UNITED STATES PATENT AND TRADEMARK OFFICE

APPLICATION NO.	FILING DATE	FIRST NAMED INVENTOR	ATTORNEY DOCKET NO.	CONFIRMATION NO.
10/687,582	10/20/2003	Keiichiro Yoshihara	C14-163313M/YAH	2459

Office Action Summary	Application No. 10/687,582	Applicant(s) YOSHIHARA ET AL.	
	Examiner Leonid Shapiro	Art Unit 2629

FIG. 1

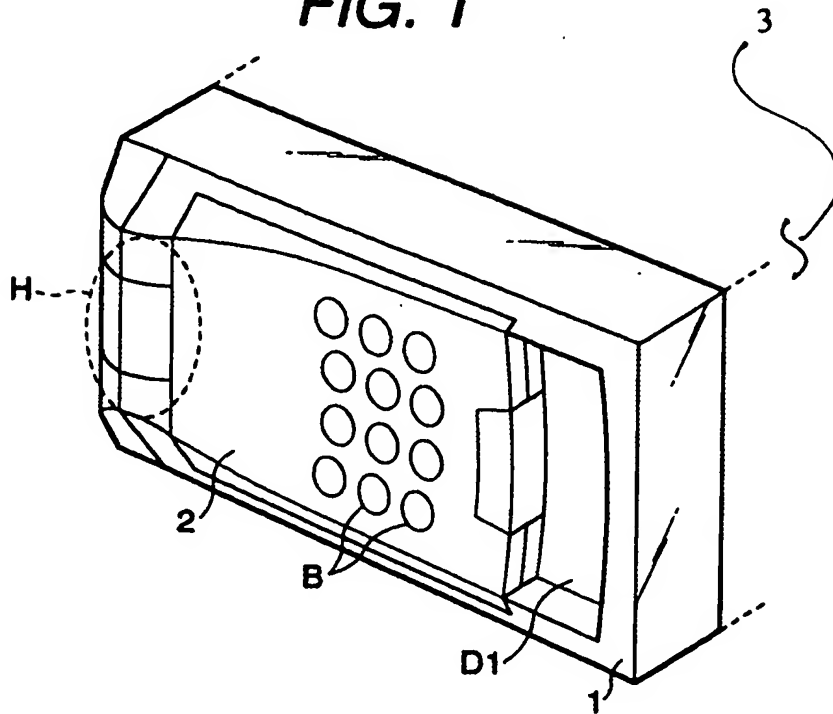
On page 12, 3rd and 4th paragraphs of Remarks, Applicant's stated that the first panel 13 shown in Drawing 1 of Satoru is not clearly not mountable onto the surface to which it is affixed when viewable by a user. However, the newly changes to the Fig. 1 and specification show that not the first panel is **directly** mounted to the dashboard, but the box-shaped case 1 (containing the first panel), that mounted to the dashboard. The same kind of box-shaped case used by Satoru reference to mount the first panel to the surface of a vehicle.
